RE: 36-DR-2024
Ty Jenkins Hangar
75Q68 (Key Code)

Response letter / summary of modifications

AIRPORT AUTHORITY SITE PLAN

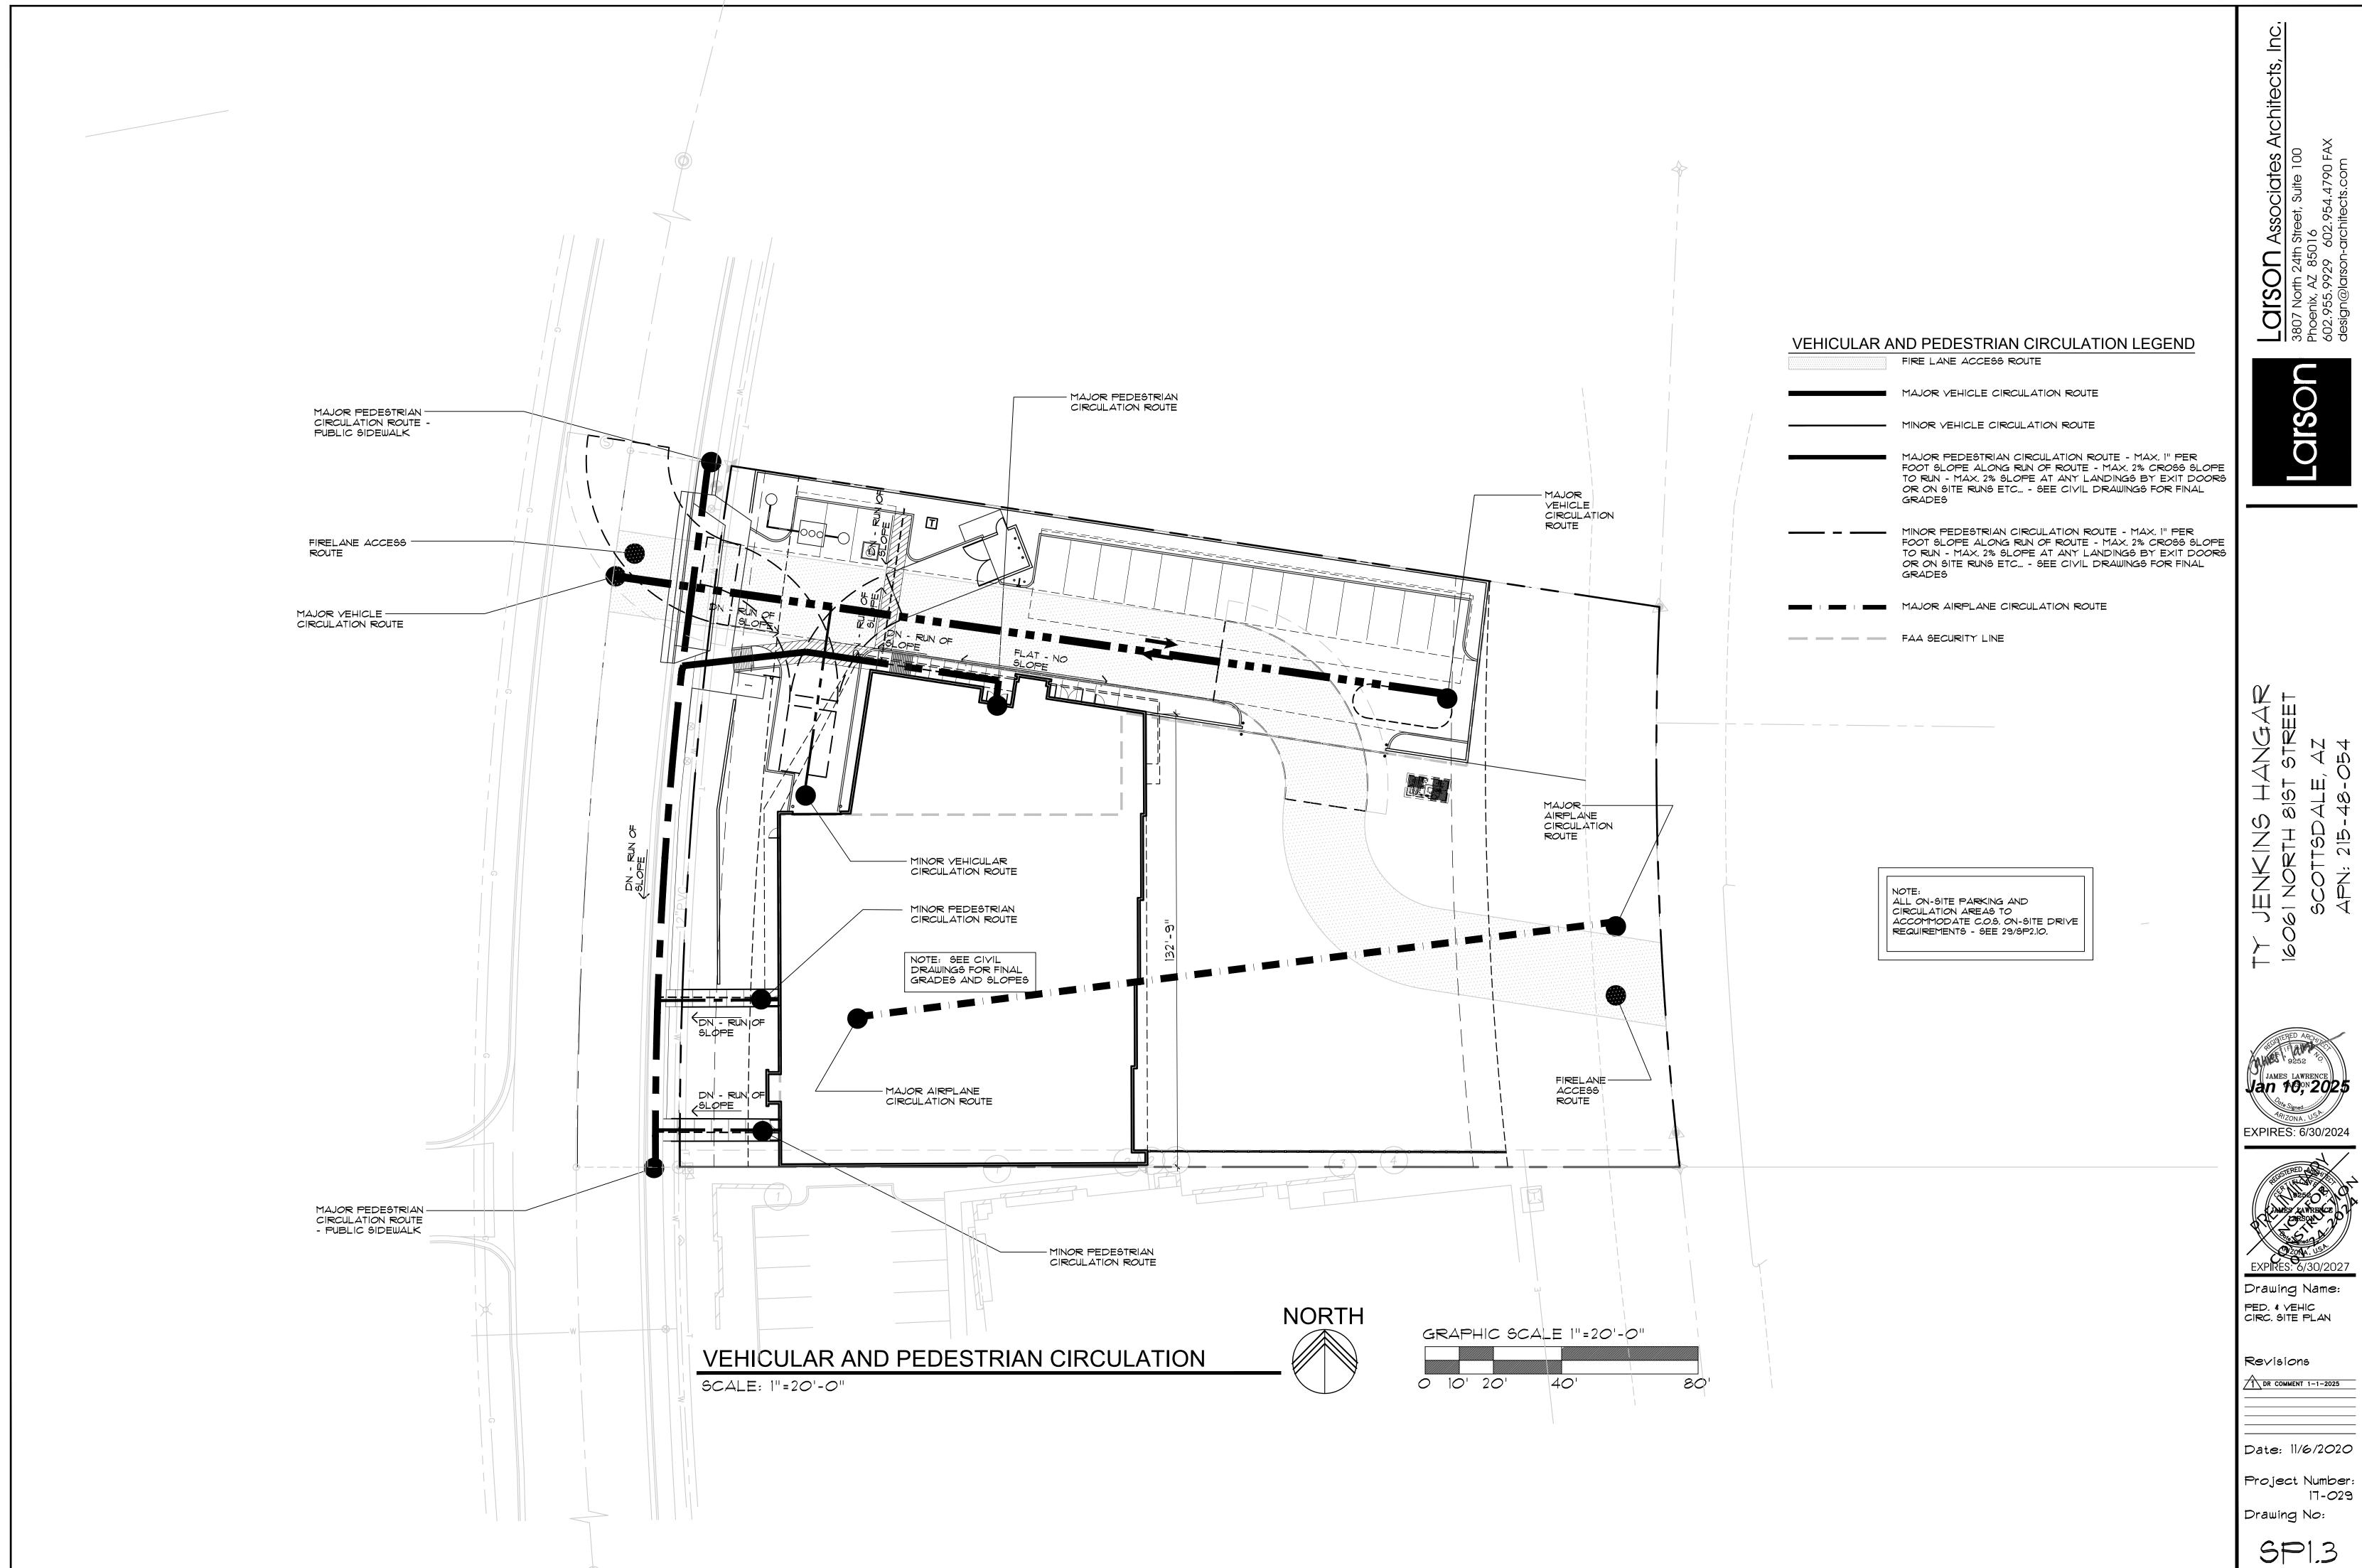
- 2. Be advised there is an approved helicopter pad adjacent to the property. We have been advised, thank you
- 3. Please confirm the height of the gate mentioned in keynote 16/SP1.0 of the site plans. gate height is 8'-0" and note has been added to keynote 16/SP1.0 and note 19/SP2.5 corrected
- 4. Please confirm if there is an entry way or driveway with a gate entering the hangar. Aviation staff unsure of what the plan is for that area.

There is a gate entering the staging area see keynote 16/SP1.0

There is also an overhead garage door / driveway that enters the hangar at the northwest side of the building. Please note the driveway doubles as a turnaround for Scottsdale garbage collection. The garbage truck does not enter the building
